Architectural Review Board City Council Chamber, Fourth Floor Noel C. Taylor Municipal Building

May 12, 2016 5:00 p.m.

Subject: Request from Marcus Lockhart, represented by Christina

Subject: Request from James G. & Ann S. Haynes, represented

FABRICATE ONE (I) 6" X 2'0" HANGING ALUMINUM SIGN AND INSTALL ON BRACKET UNDER EXISTING "DOWNTOWN ROANOKE, INC." SIGN

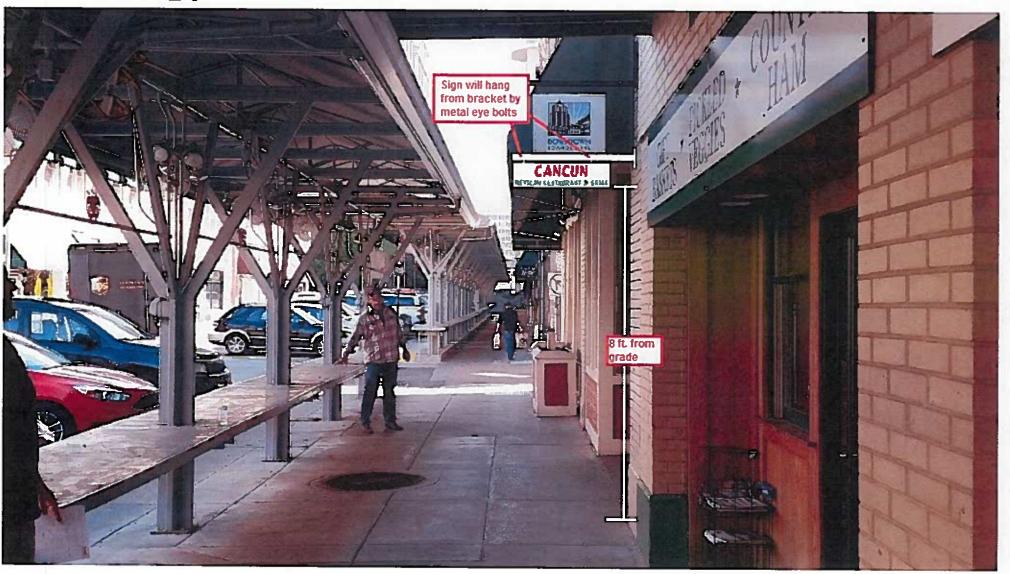
The proposed sign is in pedestrian scale and is in keeping with the existing signs within the Market Street (H-1) Historic District. The small sign is proposed right below an existing projecting sign, but due to its proposed size/shape, it would not produce a visual clutter.

The proposed sign would be easily visible to the pedestrians. The proposed sign would be located behind the existing Market Street canopy at the street curb, so it may only be partially visible to motorists.

The sign is proposed as an enameled 0.063" thick aluminum material attached rigidly to a simple bracket. A wood projecting sign exists on this façade and the new sign is proposed to fit right under the existing sign. Other aluminum signs, such as the one proposed, have previously been approved by the ARB within the H-1 Historic District.

The proposed projecting sign seems to be consistent with the H-1 Design Guidelines, except for the proposed material. The Guidelines recommends the use of wood for sign material. The projecting sign is proposed to be 0.063" thick, enameled aluminum with vinyl graphics. The ARB has previously approved similar sign materials within this district. Therefore, staff recommends approval of the COA application as proposed.

Trim Out Porch Columns

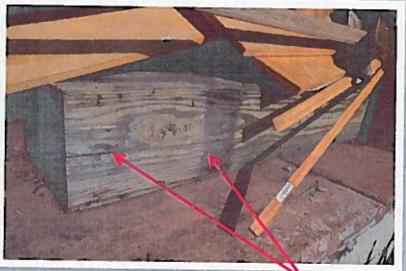
Based on the evidences on the original columns, they seem to have included brackets and necking. The applicant is proposing to install decorative column brackets and necking, per the sample photo provided in the application packet.

Additional 6" by 6" columns had been erected on the front porch. The applicant is proposing to install decorative column brackets and necking, per the sample photo provided in the application packet. However, the bracket styles proposed appear to be over-sized, and alternative brackets with softer appearance may need to be considered.

Trim Out Porch Columns

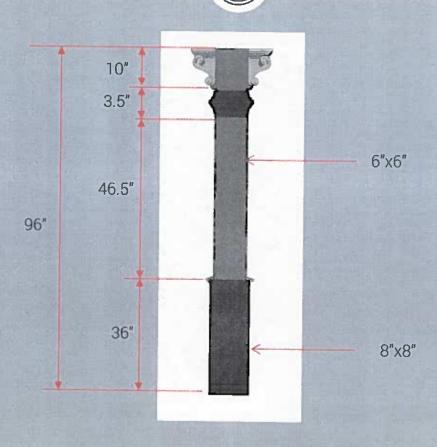
- 1- The bracket styles on the front porch columns appear to be over-sized, and alternative brackets that are more delicate and consistent with decorative columns within the district may need to be considered.
- 2- The front porch has concrete foundation walls, and no lattice work is proposed as part of the COA application. However, the use of a lattice with horizontal and vertical strips is recommended, if necessary.
